<b>Subject:</b> RUST AROUND REAR VIEW CAMERA AND/OR LIFTGATE OPENER SWITCH	<b>Bulletin No:</b> 09-002/17
	<b>Last Issued:</b> 01/13/2017

2016-2017 CX-3

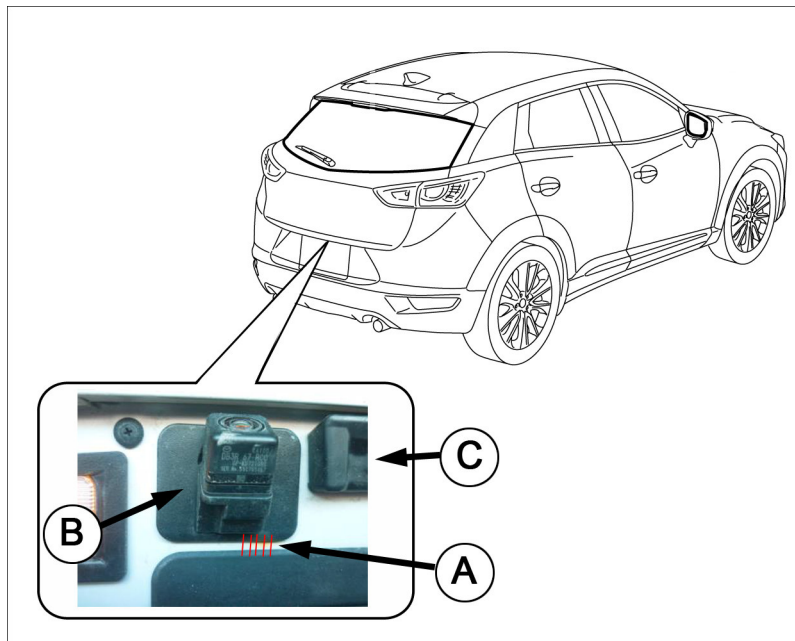
Some vehicles may exhibit rust (A) on the liftgate around the border of the rear mount camera (B) and/or the liftgate opener switch (C). Repair the paint rust and install a pad to prevent future paint rust.

A	Protector Film
B	Installation Hole for Rear Mount Camera
C	Installation Hole for Liftgate Opener Switch

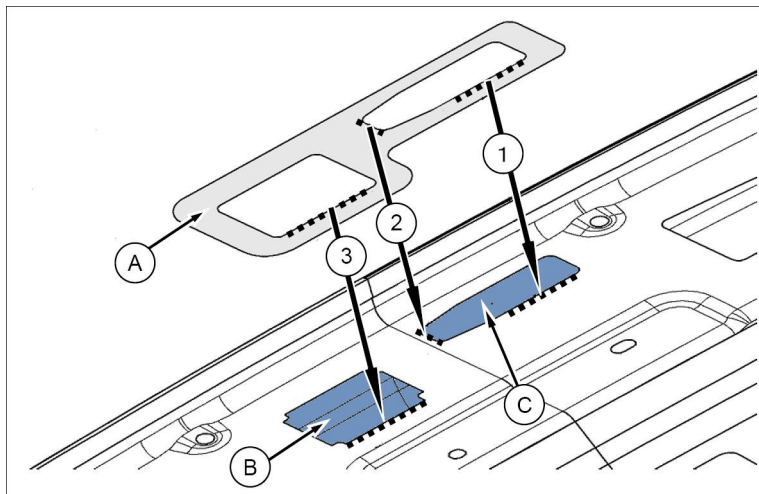
1. Verify customer concern.
2. Repair the affected area of the liftgate by ordinary paint rust damage repair procedure.  
**NOTE:** Repair affected area(s) only. There is no need to repaint the whole liftgate.
3. To prevent direct interference of the rear mount camera and liftgate opener switch mount bases with the liftgate paint surface, attach a protector film (DBY0-62-864) to the liftgate.

- Degrease the liftgate where the protector film is attached.
- The protector film (A) must not cover the installation holes for the rear mount camera (B) and liftgate opener switch (C). To attach the protector film in the correct position, first align three edges (marked with 1 - 3 in figure) of the protector film with three edges (marked with 1 - 3 in figure) of the installation holes, and then attach the whole protector film without leaving air bubbles.
